# Sydney Gateway Road Project

## Major Development Plan

### Refinements and Clarifications

#### Section 1 Project refinements and clarifications

Figure 1.1 Proposed realignment to avoid the Cooks River Intermodal Terminal

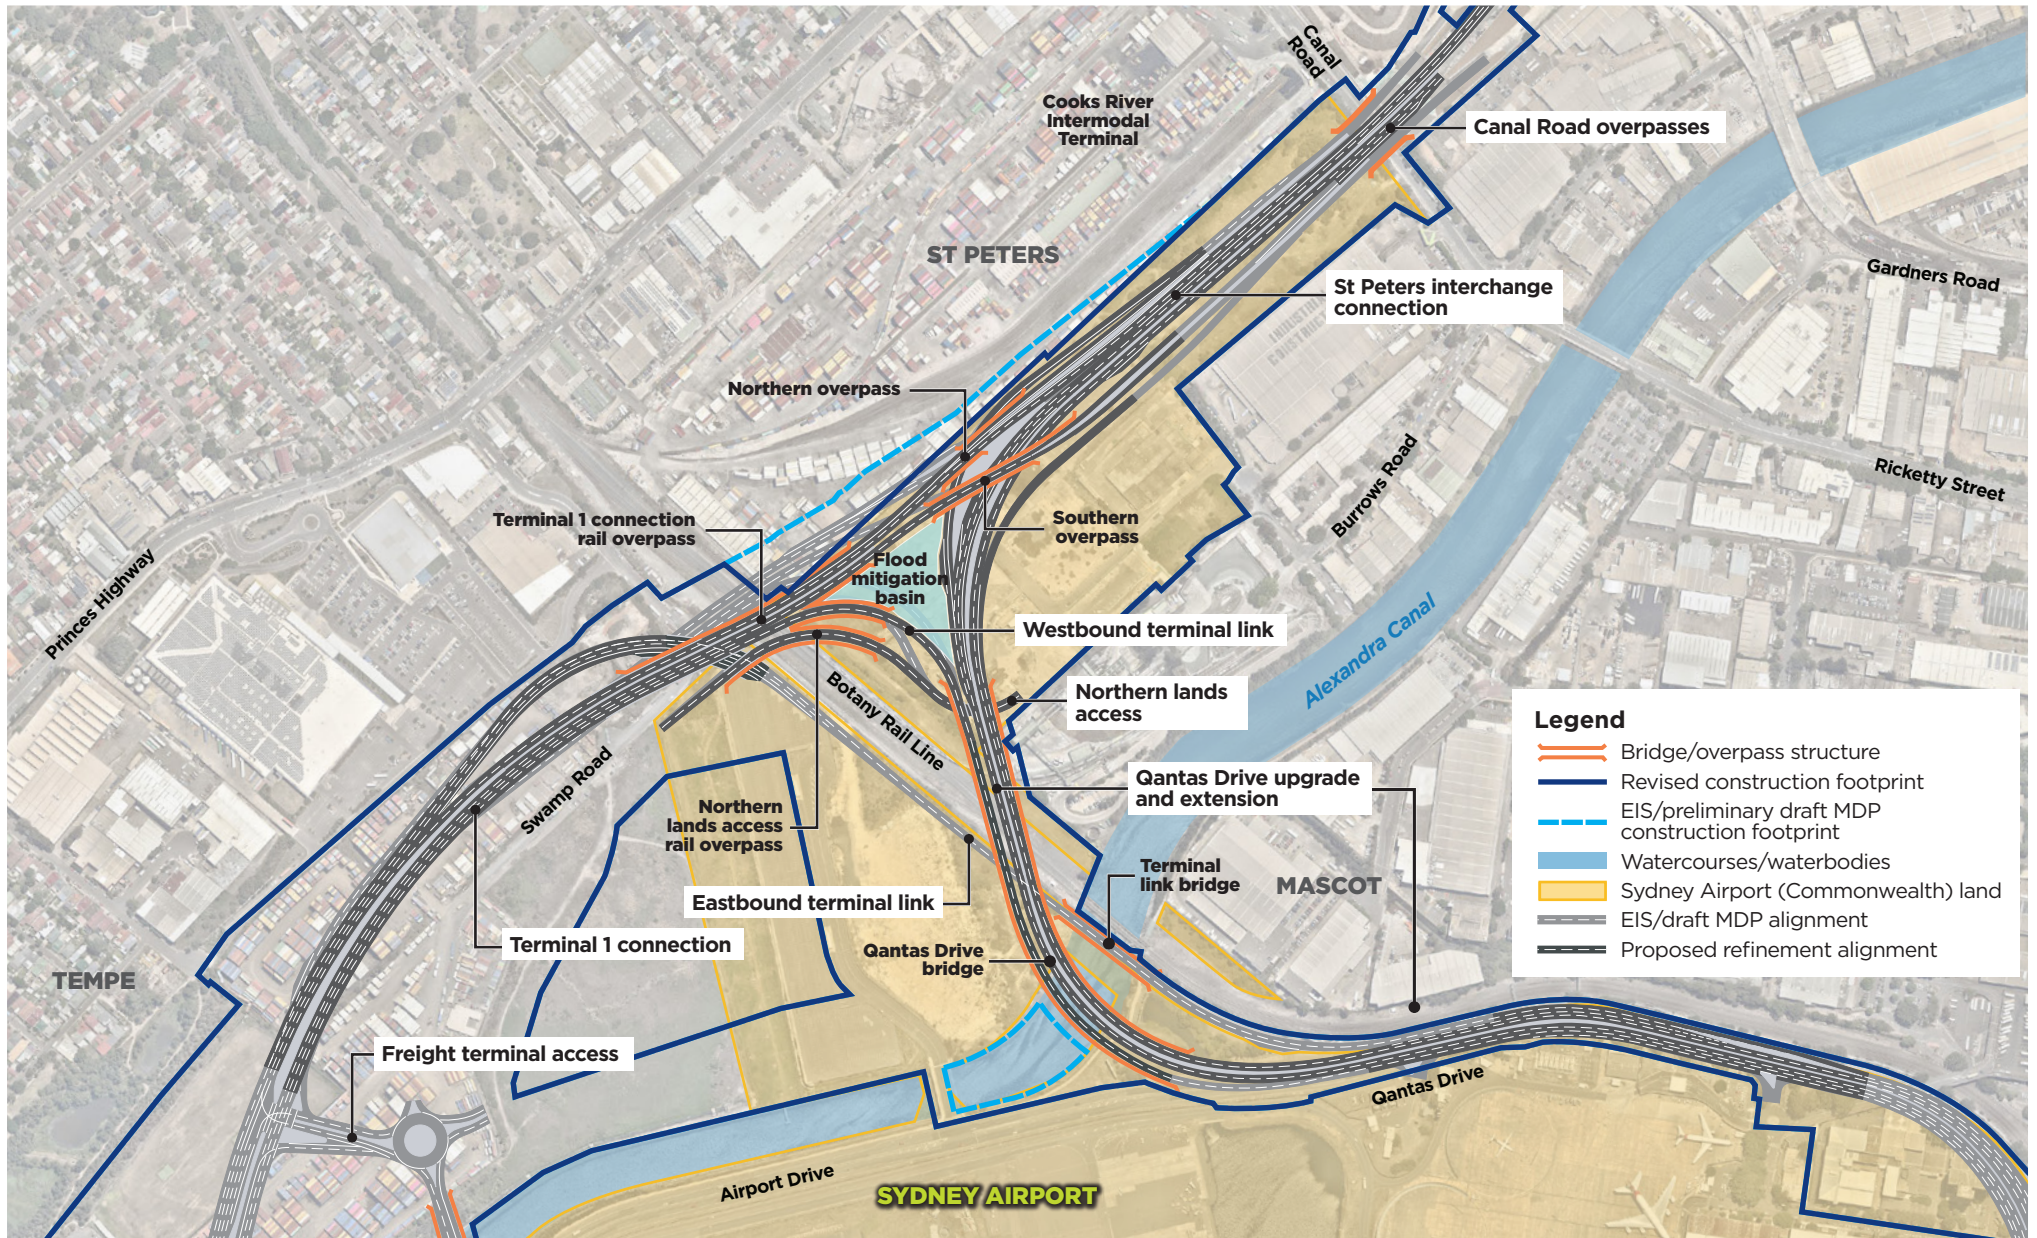
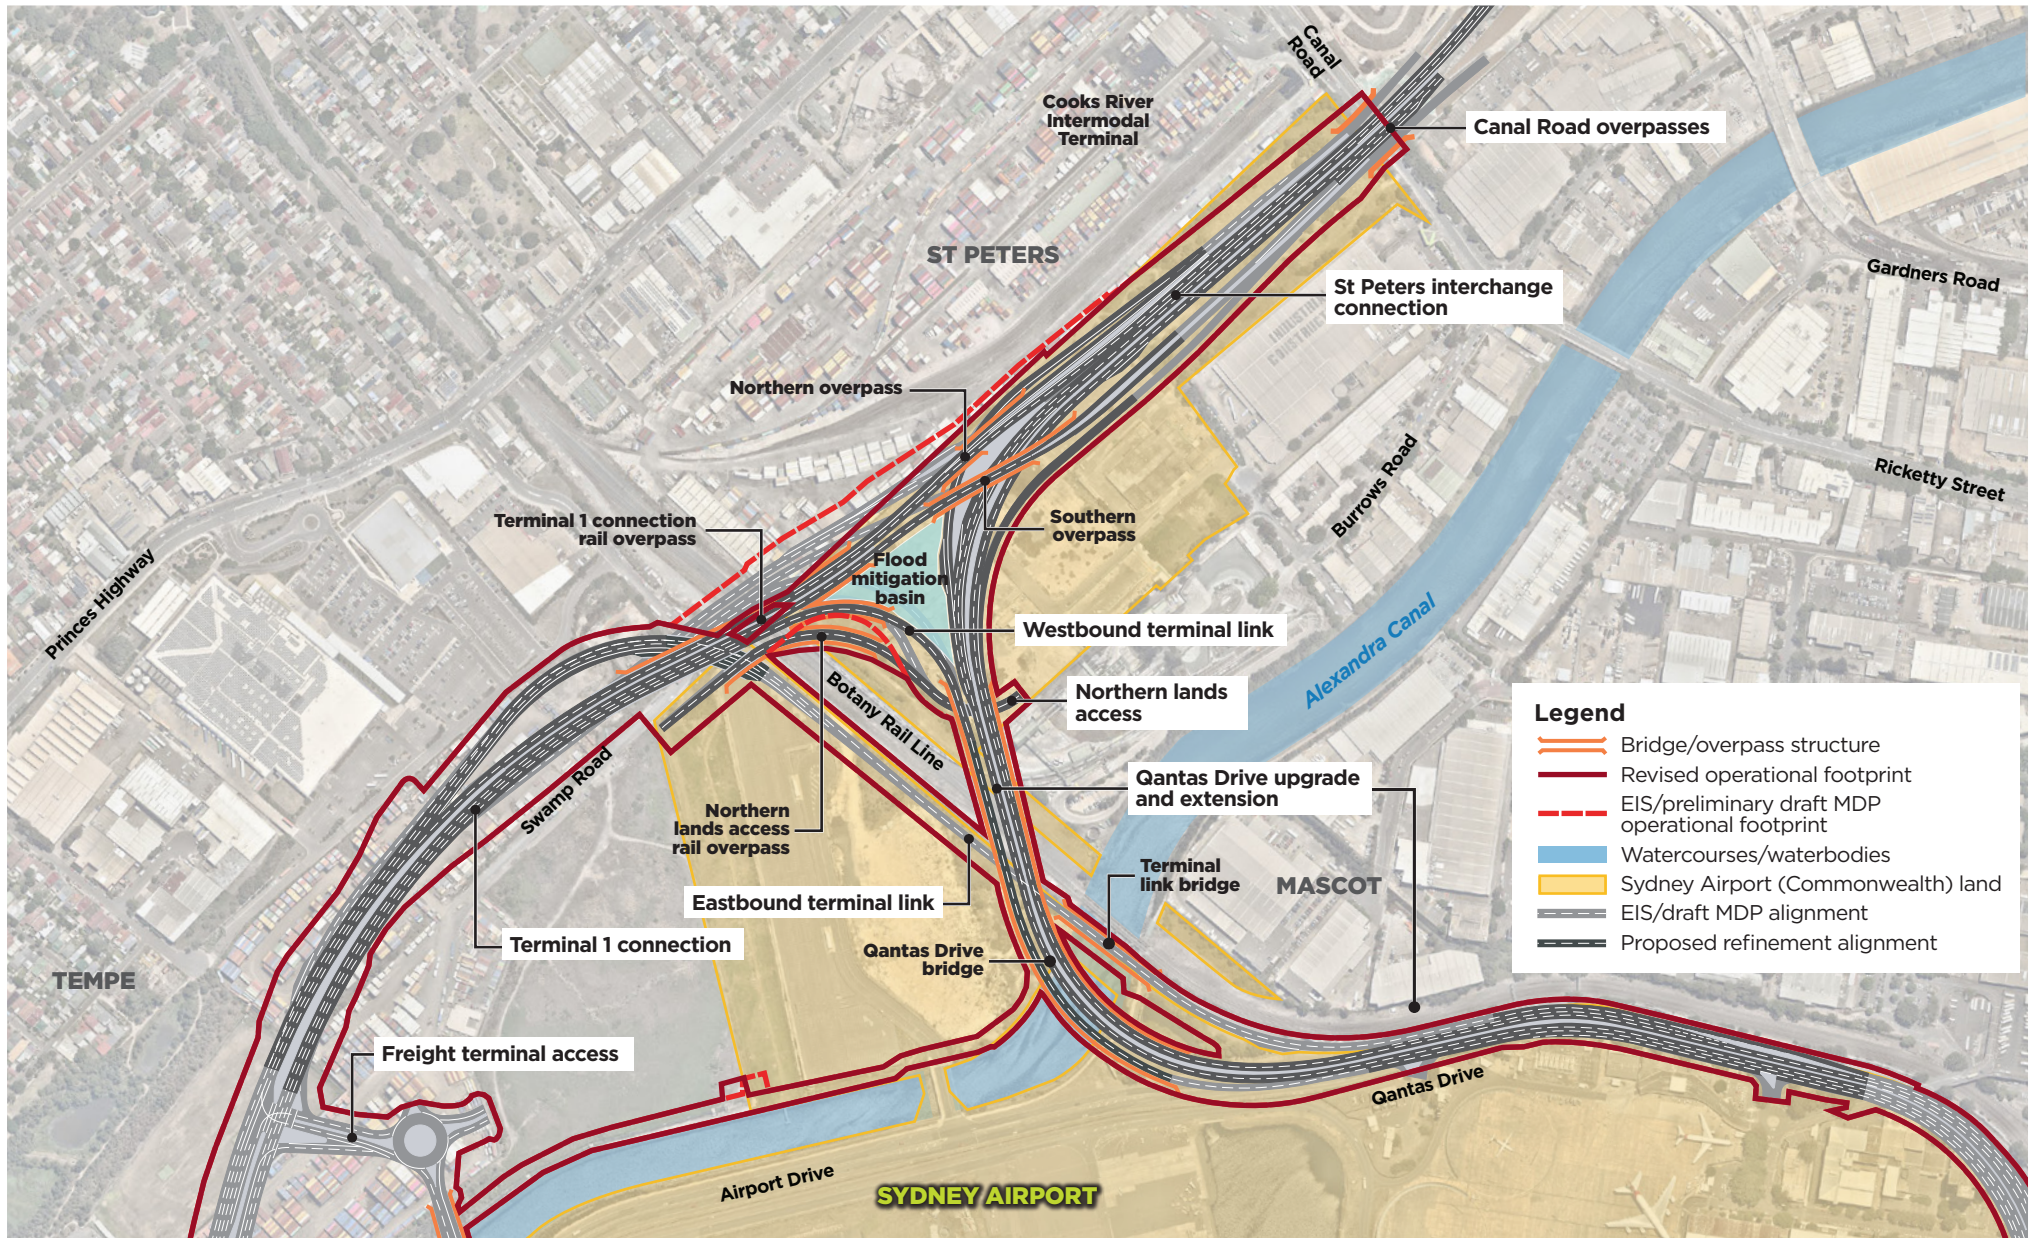
Following consultation with the landowner and operator in 2019, it is proposed that the St Peters interchange connection would be realigned to avoid direct impacts on the Cooks River Intermodal Terminal.

This proposed refinement would remove the requirement for land at the Cooks River Intermodal Terminal and reduce the project's impact on land used for empty container storage. It would also avoid direct impacts on the terminal's infrastructure located on the required land, and potential impacts on site operations.

The St Peters interchange connection would be realigned about 35 metres south-east of the original alignment. As a result of the interconnected nature of a number of adjoining road sections and infrastructure, the realignment would also result in flow-on changes to these features by a similar (or smaller) amount. This would result in minor changes to the alignment of the Terminal 1 connection, northern lands access, eastbound terminal link and westbound terminal link.

The proposed flood mitigation basin (described in section 7.10.8 of the EIS/MDP) located between lanes of the St Peters interchange connection and the westbound terminal link would be modified to account for the change in alignment. The indicative extent of the modified basin is shown on Figure 1.1. The total area of the basin would change as a result of this refinement; however, the storage volume and function would remain the same.

The proposed refinement would reduce the project's land requirements and the construction and operational footprints. The new footprints are shown on Figure 1.1 and Figure 1.2.

**Figure 1.3 Proposed emplacement mound and additional stub road to residual land**

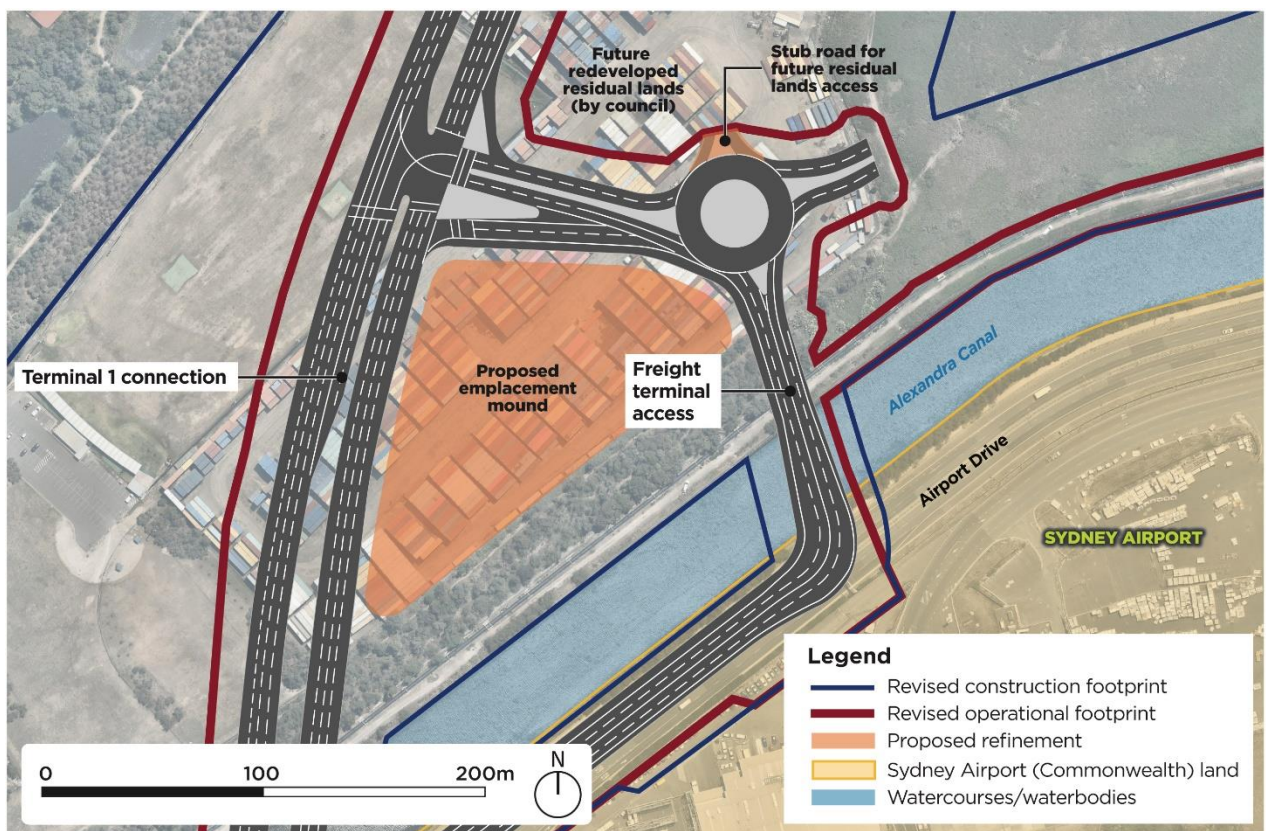
Figure 1.3 shows the location of the proposed single mound. This mound is proposed in the same location as the single mound described in section 7.10.2 of the EIS/MDP. The design of the mound would be as described in section 7.10.2 with the mound to contain about 35,000 cubic metres of waste material excavated from the former Tempe landfill. It would have a maximum height of 13.6 metres above the existing ground level and would occupy an area of about three hectares. The mound would be designed in accordance with the requirements the *Environmental Guidelines: Solid waste landfills* (NSW EPA, 2016). Access to the mound would be limited. The area would be appropriately fenced off to ensure no public access.

The indicative construction methodology would be as described in section 8.2.5 of the EIS/MDP. However, as only one mound is now proposed, there would now be a need to remove about 55,000 cubic metres of excavated landfill material from the site for disposal at an appropriately licensed landfill.

Removing this material would result in an estimated additional 6,900 truck movements. This traffic would use access point A7 and the corresponding haulage route along Bellevue Street to the Princes Highway described in section 8.6.1 of the EIS/MDP and shown on Figure 8.19 of the EIS/MDP.

The EIS/MDP did not include specific details about how this land would be accessed from the project. Following consultation with Inner West Council, it is proposed to provide a stub road connection on the freight terminal access roundabout. This would facilitate future road connections and improved access to and from the residual land. Future internal access requirements would be confirmed by Council's master plan.

The proposed refinement is located on the northern side of the freight terminal access roundabout as shown on Figure 1.3.

Figure 1.4 Proposed pedestrian crossing at Seventh Street

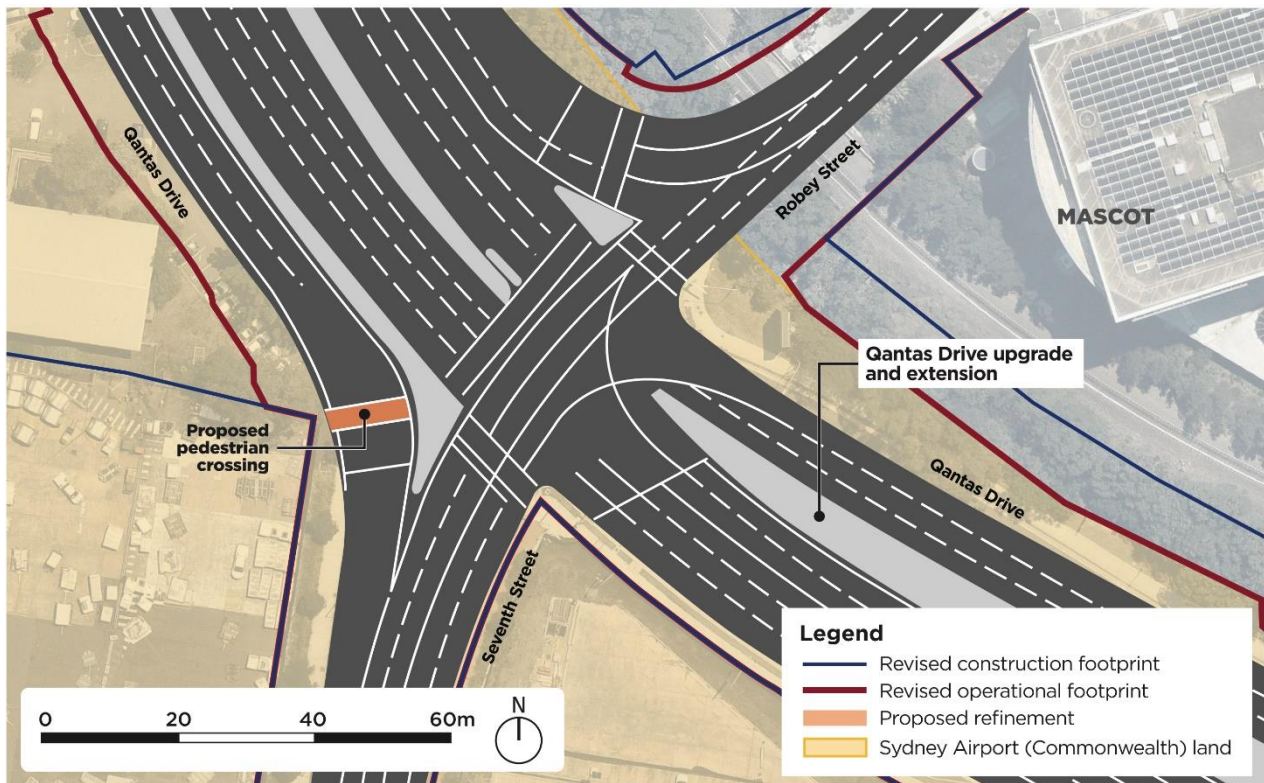
As described in section 7.4.2 and shown on Figure 7.15 of the EIS/MDP, the proposed left turn lanes from Seventh Street to Qantas Drive at the Seventh Street/Qantas Drive/Robey Street intersection did not include facilities for pedestrians to cross. This means that pedestrians from Robey Street and Qantas Drive would not be able to safely access the footpath along Seventh Street or towards Terminals 2/3.

It is proposed to retain a signalised pedestrian crossing at this location. This would provide safe pedestrian access across the intersection to Terminals 2/3, including the two left turn lanes from Seventh Street to the proposed pedestrian island at the corner of Seventh Street and Qantas Drive.

Figure 1.4 shows the location of the proposed crossing. The crossing would be signalised and activated by pedestrians. This would allow the left turn lanes to operate as a free-flow movement, with the exception of when signals are activated.

**Figure 1.5 Sydney desalination pipeline maintenance turning area**

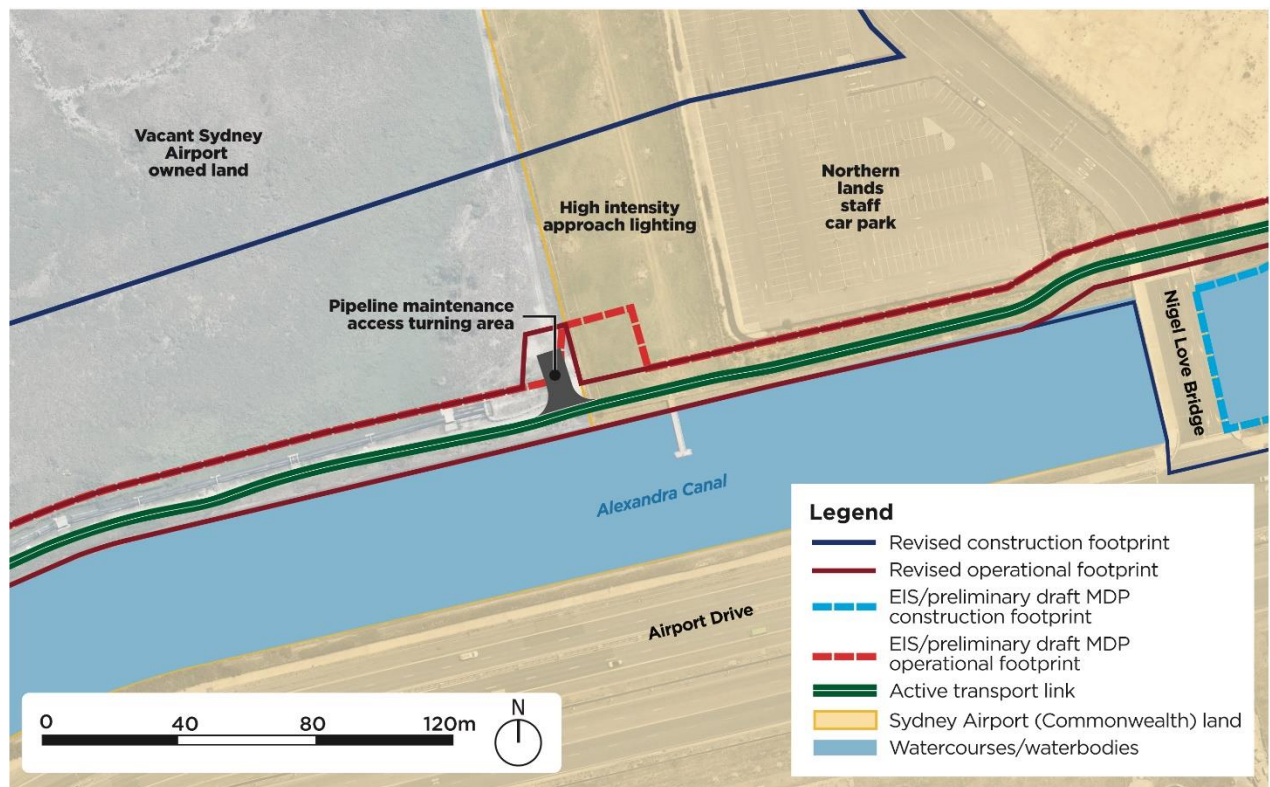
Figure 1.5 shows the location of the proposed refinement. A paved vehicle turning area would be constructed on the western edge of the land occupied by the high intensity approach lights, adjacent to the proposed active transport link. The location of the proposed turning area is shown on Figure 1.5.

The proposed refinement is located on land subject to the EP&A Act. The proposed refinement would result in minor changes to the operational footprint and permanent land requirements (see Figure 1.5 and Table 1.1). The acquisition or lease arrangements would be as described in section 19.3.1 of the EIS/MDP.

Figure 1.6 Additional construction area for active transport link crossing

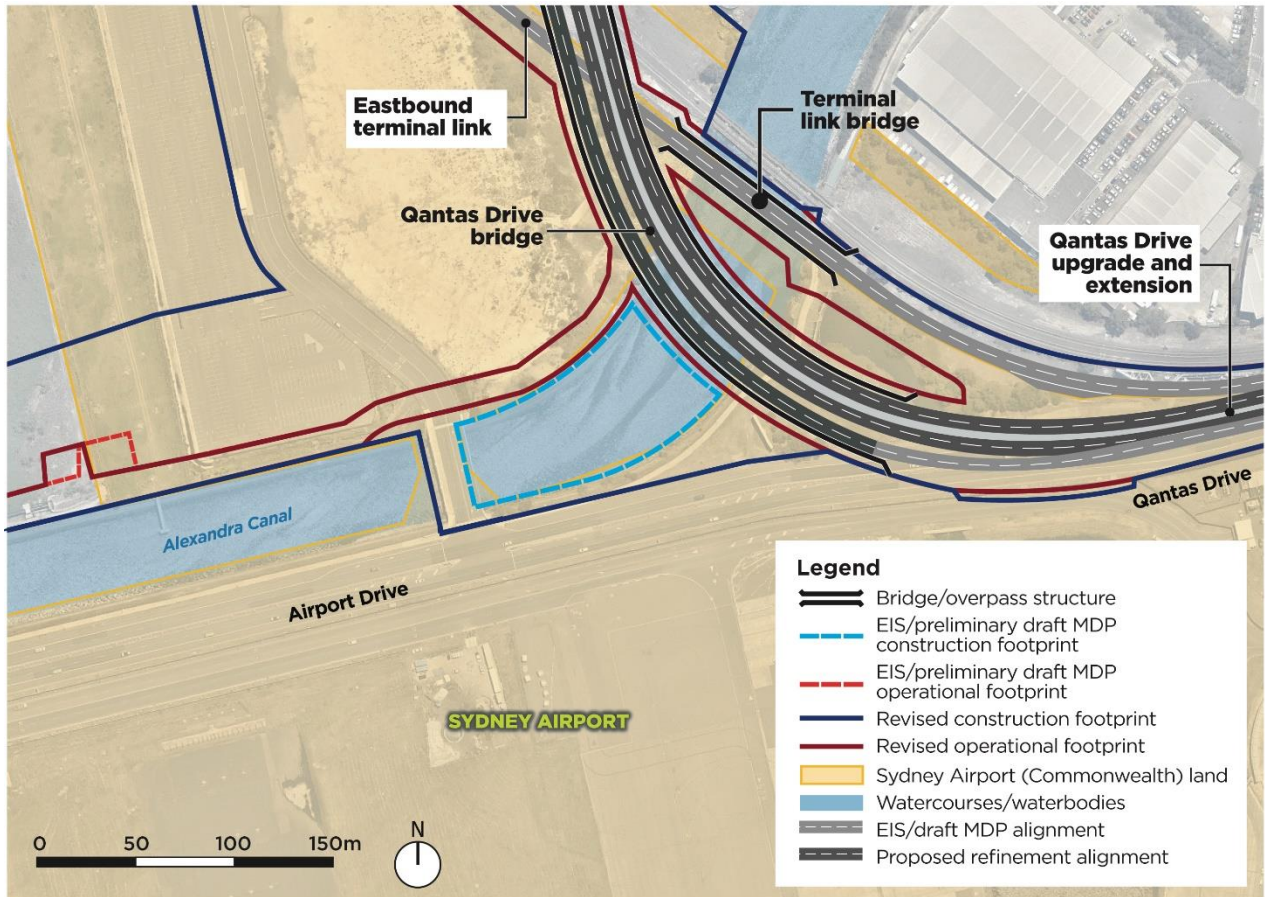
The proposed refinement involves an adjustment to the construction footprint to provide flexibility for the design of the active transport link crossing of Alexandra Canal.

The proposed refinement would result in minor changes to the construction footprint over Alexandra Canal (see Figure 1.6) and the project’s temporary land requirements (see Table 1.2). The acquisition or lease arrangements would be as described in section 19.3.1 of the EIS/MDP.
